**CITY OF BLOOMINGTON
PLAN COMMISSION AGENDA
Nov. 7, 2011 @ 5:30 p.m.**

**BLOOMINGTON PLAN COMMISSION
PRELIMINARY REPORT
LOCATION: 718-720 East 8th Street**

**CASE #: ZO-27-11
DATE: November 7, 2011**

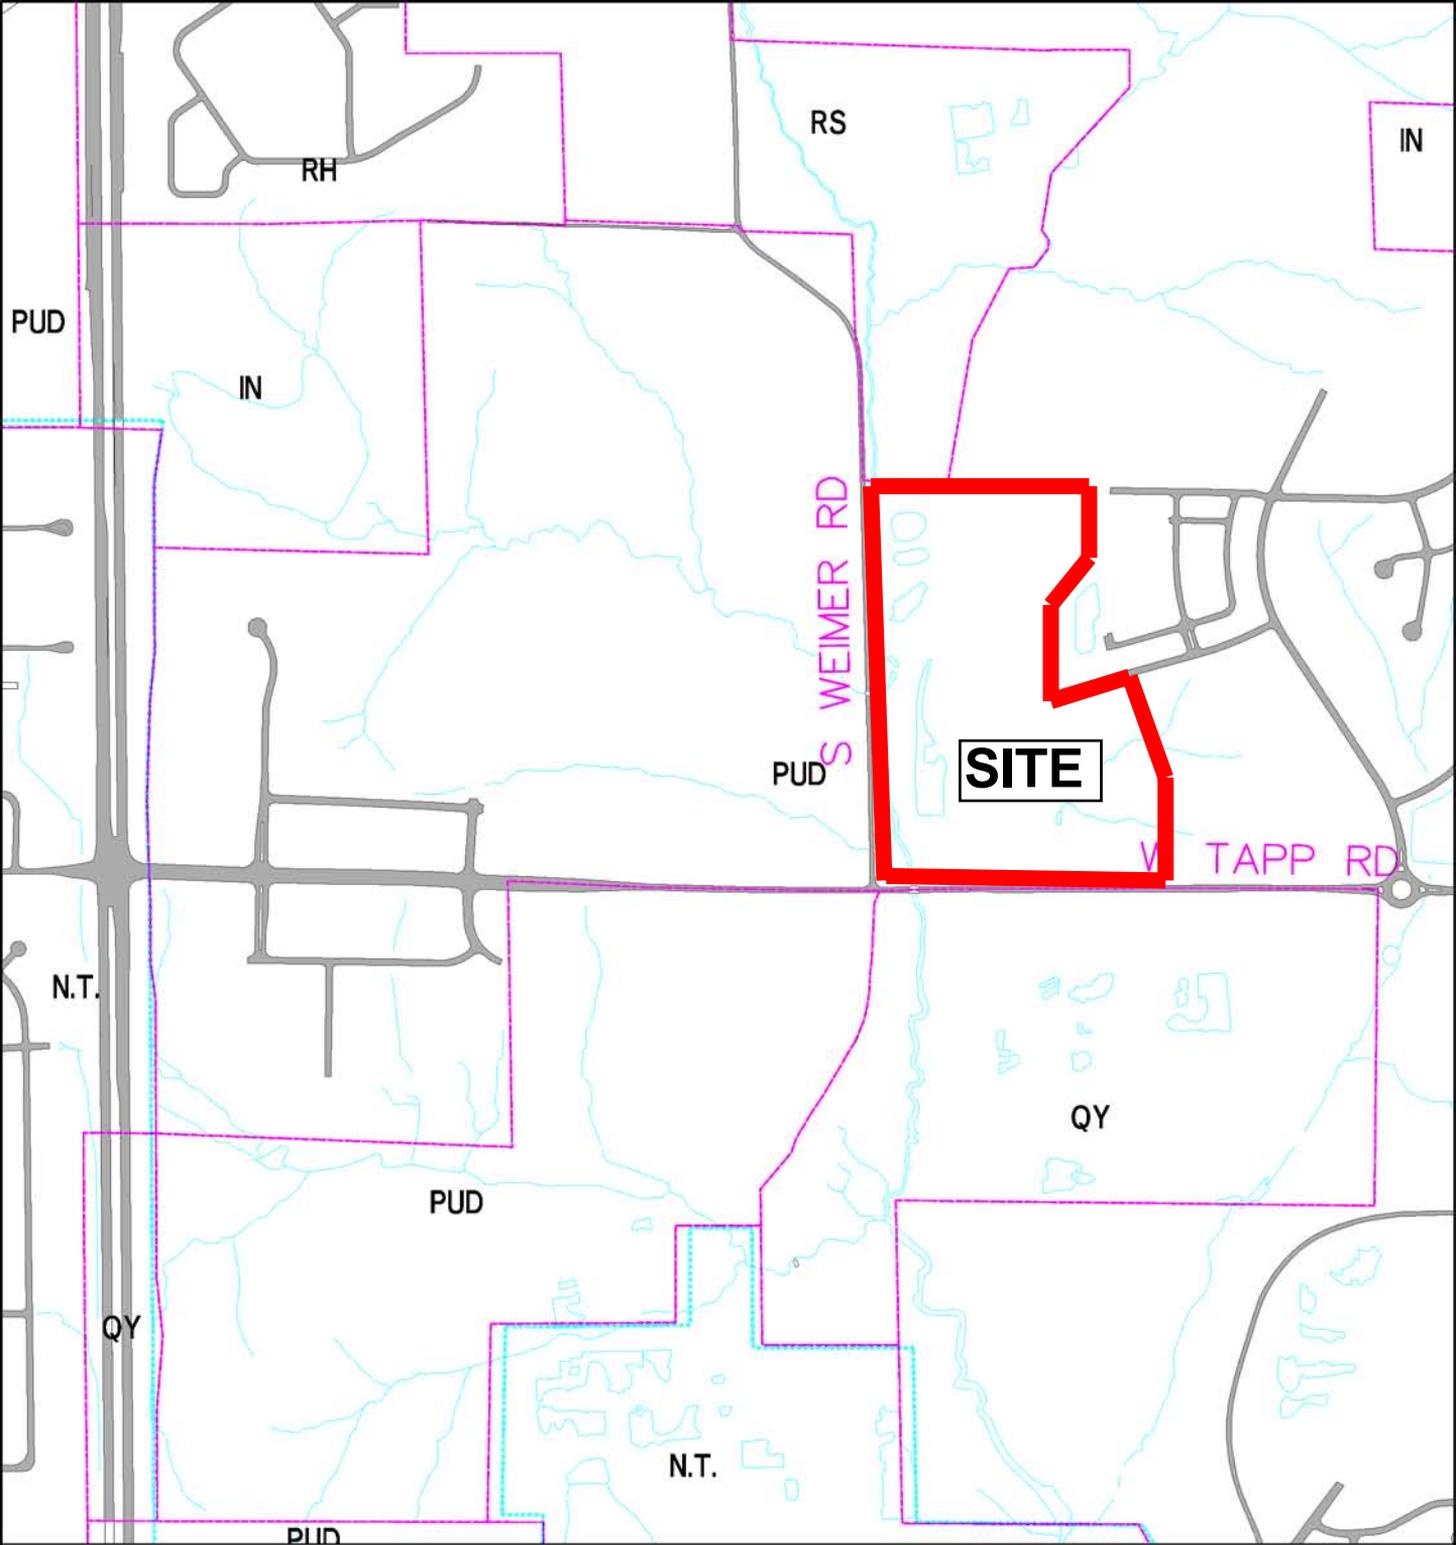
Additionally, a metal pole-barn building is generally considered neither attractive or energy efficient. The EC would encourage the developer to re-design the building to fit better with the esthetics of the surrounding area rather than distract from the unique picturesque look of the rest of the PUD.

The EC recommends that the areas north and west of the building, which are planned with traditional landscaping, be re-designed as biofiltration swales. The islands in the parking lot should also be redesigned to be biofiltration swales, thus stormwater from the building and parking lots can be slowed down and filtered before it enters the floodplain as described in UDO 20.05.070 (m) Parking Standards; Surface Material.

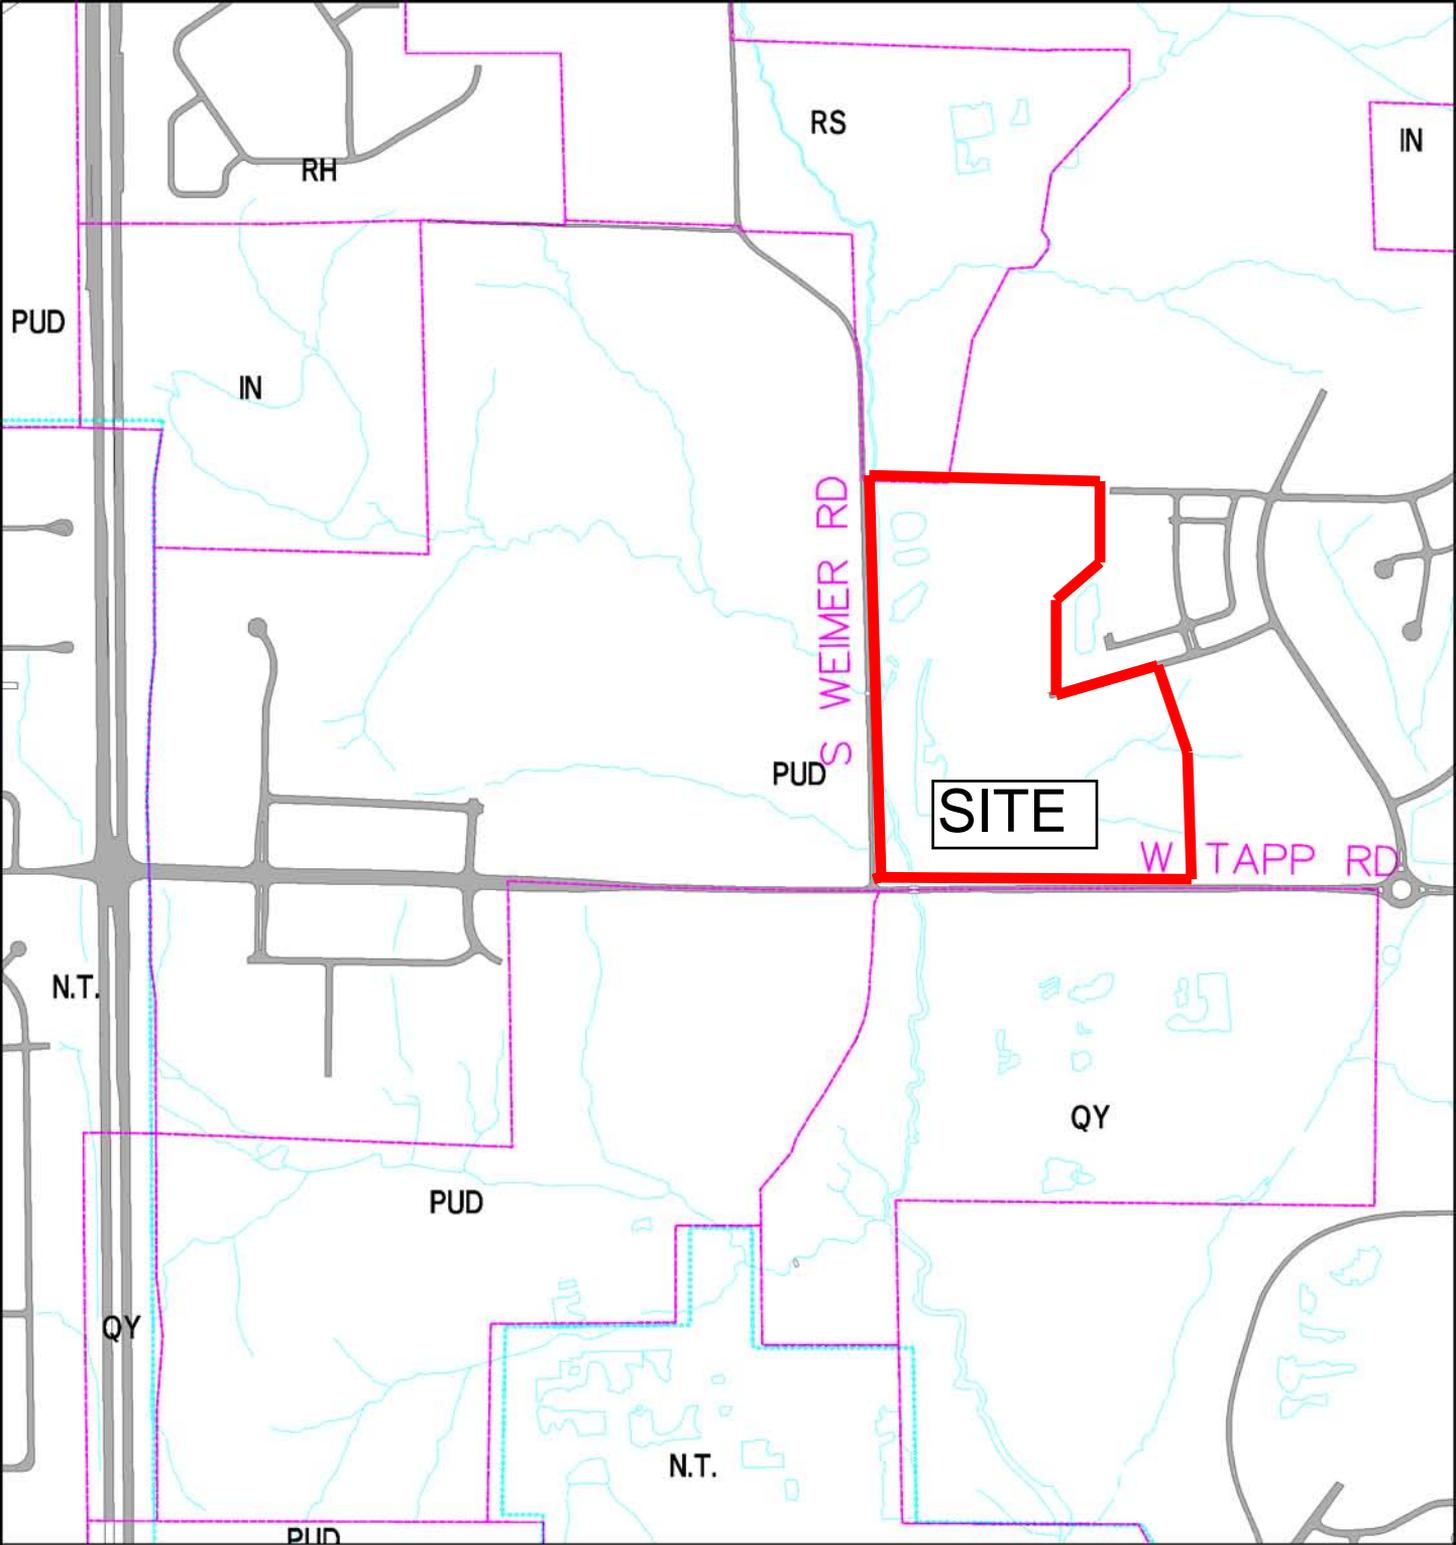
The site is home to several karst or pseudokarst* features in its northeast corner. These sinkhole-looking features were briefly looked at and considered during review of the Woolery Mill Complex PUD-35-01 in 2001. At that time it was unclear if they were naturally-occurring sinkholes, or if they were pseudokarst sinkholes developed from soil piping through fill. Whether or not the soil piping resulted from naturally-occurring dissolution of limestone, or migration through watercourses between unconsolidated materials is not relevant. With either scenario, the features behave like sinkholes in that they are direct conduits to groundwater and should have conservation buffers surrounding them.

The petitioner should take one of two actions before a future Final Plan is submitted for the northeast corner of the site. One choice is to conduct a geologic study of the subsurface to determine the validity and extent of the sinkholes prior to delineating a Karst Conservancy Easement. The other choice is to delineate a Karst Conservancy Easement, with an associated 10 foot building setback, based on the surface expression and regardless of the provenance of the sinkholes.
